DEPARTMENT OF TRANSPORTATION -Toll Bridge Program

Contract No. 04-0120F4
04-SF-80-13.2 / 13.9
Self-Anchored Suspension Bridge
Letter No. 05.03.01-007769

Submittal 1636 & Transmittal 3691, Rev. 1 - June 2010 Schedule

B4. Lifts 13 and 14 Bike Path and Counterweight Installation

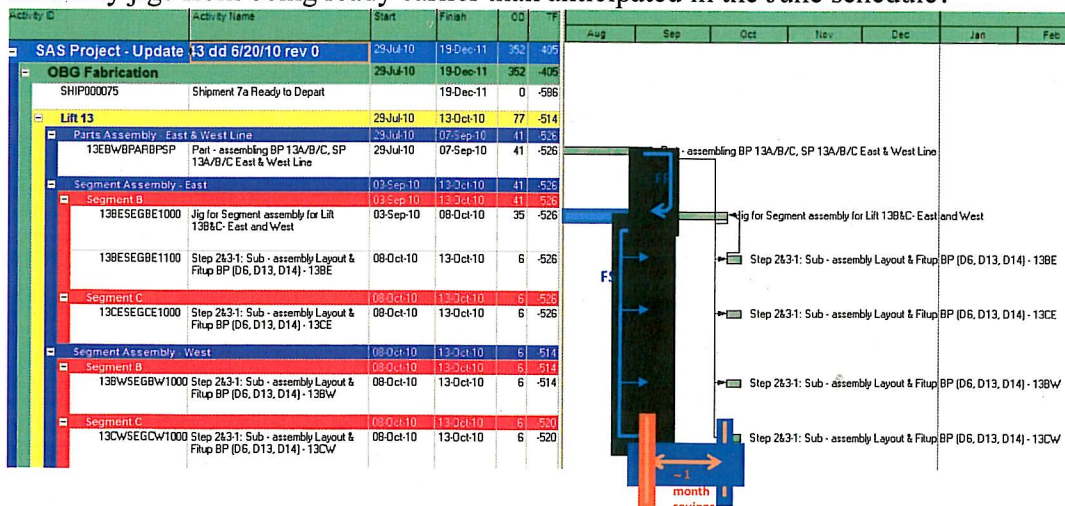
The schedule currently shows installation of the Lifts 13/14 counterweight prior to load transfer and bike path installation after load transfer. Review and revise logic as necessary.
